199-118 CONVERSION KIT

CONVERSION OF 40-120 OR 40-120C WHEEL TO USE SLOTTED BRAKE DISC.

## CONVERSION OF CLEVELAND 40-120 AND 40-120C MAIN WHEEL TO USE SLOTTED BRAKE DISC, PART NUMBER 164-21600

CHECKED BY		Parker		
				SCALE NONE		NAME WHEEL MODIFICATION DRAWING		
						50-93

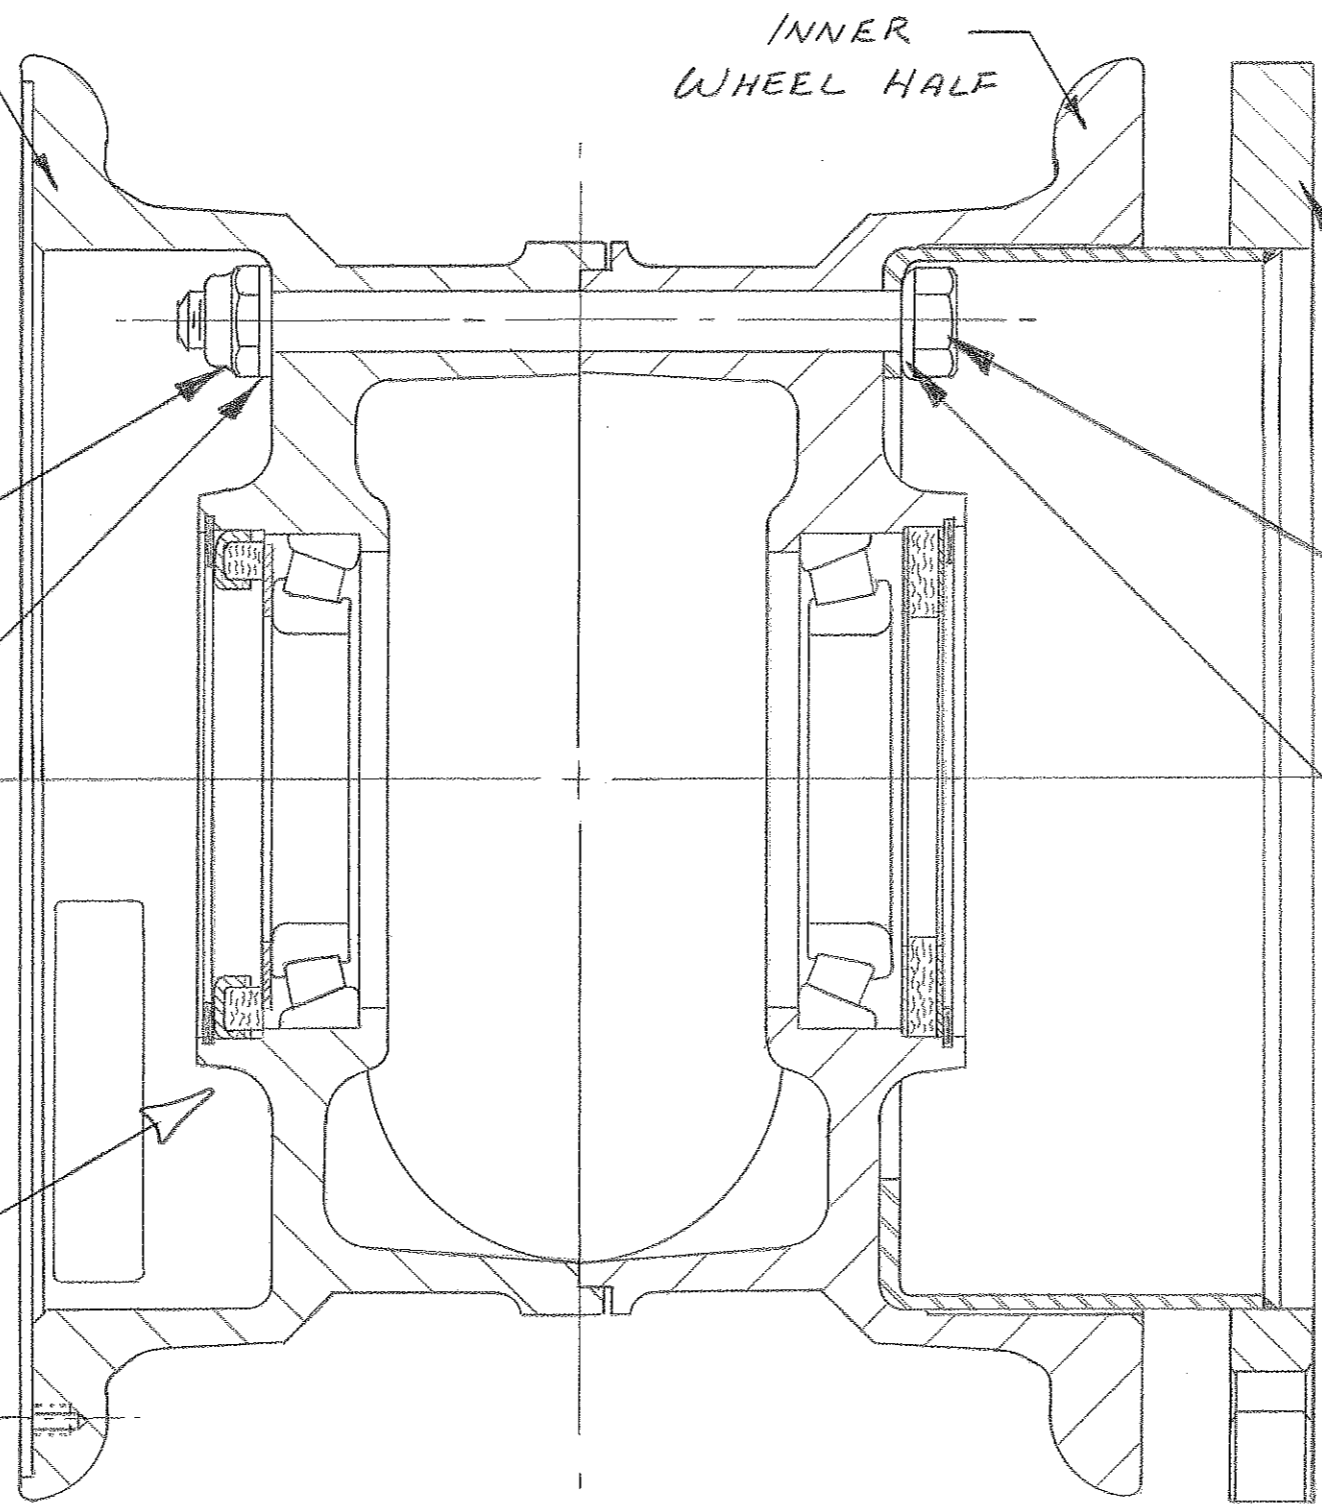
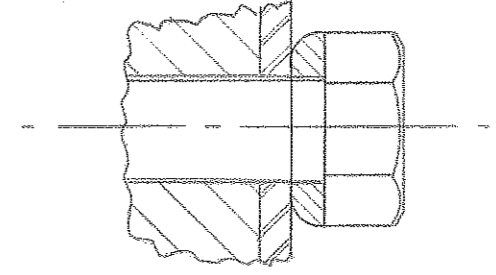
NOTE: RADIUSED SIDE OF 095-03000 WASHER TO BE FACING AWAY FROM BOLT HEAD AS SHOWN ABOVE

NOTE  
THIS DRAWING DEPICTS A 40-120 OR 40-120C WHEEL ASSEMBLY AS MODIFIED TO USE SLOTTED DISC P/N 164-21600 PER CLEVELAND CONVERSION KIT 199-118 AND P.R.M. # 33.
